APPLICANT: Michael B. Kennedy	PETITION NO:	Z-12
PHONE#: 678-939-0452 EMAIL: mikek.gce@gmail.com	HEARING DATE (PC):	02-03-15
REPRESENTATIVE: Michael B. Kennedy	HEARING DATE (BOC): _	02-17-15
PHONE#: 678-939-0452 EMAIL: mikek.gce@gmail.com	PRESENT ZONING:	R-20
TITLEHOLDER: Michael Kennedy		
	PROPOSED ZONING:	RA-5
PROPERTY LOCATION: East side of South Hurt Road, across from		
Donna Drive	PROPOSED USE: Resident	ial Development
(3865 South Hurt Road).		
ACCESS TO PROPERTY: South Hurt Road	SIZE OF TRACT:	3.48 acres
	DISTRICT:	17
PHYSICAL CHARACTERISTICS TO SITE: One story frame house	LAND LOT(S):	96, 121
	PARCEL(S):	15
	TAXES: PAID X DU	JE
CONTIGUOUS ZONING/DEVELOPMENT	COMMISSION DISTRICT	:_4

APPLICANT: Michael B. Kennedy	PETITION	NO.: Z-12
PRESENT ZONING: R-20	PETITION	FOR: RA-5
******	*******	*****
ZONING COMMENTS: Staff Men	mber Responsible: Terry Martin, M	IPA
Land Use Plan Recommendation: Lo	w Density Residential	
Proposed Number of Units: 14	Overall Density: 4.02	Units/Acre
Staff estimate for allowable # of units: 6 *Estimate could be higher or lower based on engineer natural features such as creeks, wetlands, etc., and other	ered plans taking into account topography, sh	Units/Lot

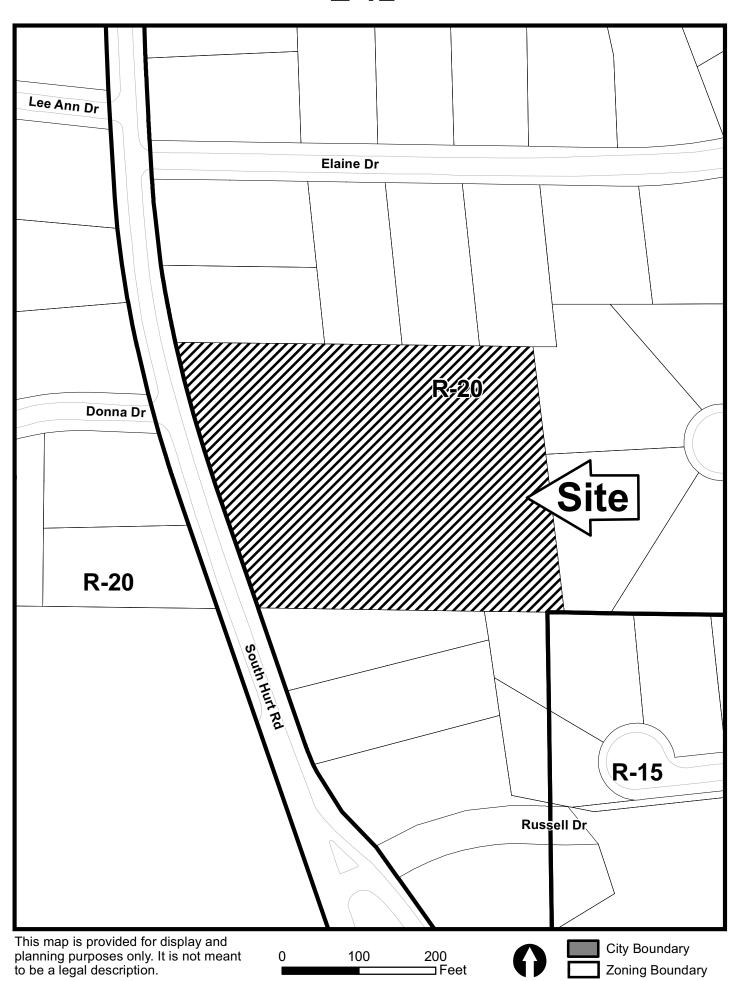
The applicant's last revised plan received by the Zoning Division on March 23, 2015 proposes a layout that differs substantially from that originally filed. In this RA-5 proposal, no lots have access to a public street, lot sizes are under the minimum required by nearly half in some cases, lot widths are deficient as are front and rear setbacks, and no perimeter landscape buffer is provided adjacent to surrounding more restrictively zoned properties. In particular, the following variances will be required for this proposal:

- 1. Waive the minimum lot size from the required 7,000 square feet to as little as 3,776 square feet:
- 2. Allow all lots to be accessed by a private street;
- 3. Waive the minimum lot width from the required 50 feet at the front setback line to as little as 40 feet:
- 4. Waive the front setbacks from the required 25 feet to as little as 5 feet;
- 5. Waive the rear setbacks from the required 20 feet to as little as 10 feet;
- 6. Waive the allowable impervious surface from the maximum 40% to as much as approximately 60%; and
- 7. Waive the required 10 foot perimeter landscape buffer.

GUEST PARKING: When projects contemplate less than 20 foot separation between units, guest parking shall be provided or the streets shall be labeled as a fire lane.

INSUFFICIENT INFORMATION	
 No Stormwater controls shown Copy of survey is not current − Additional commen are exposed. No site improvements showing on exhibit. 	ts may be forthcoming when current site conditions
ADDITIONAL COMMENTS
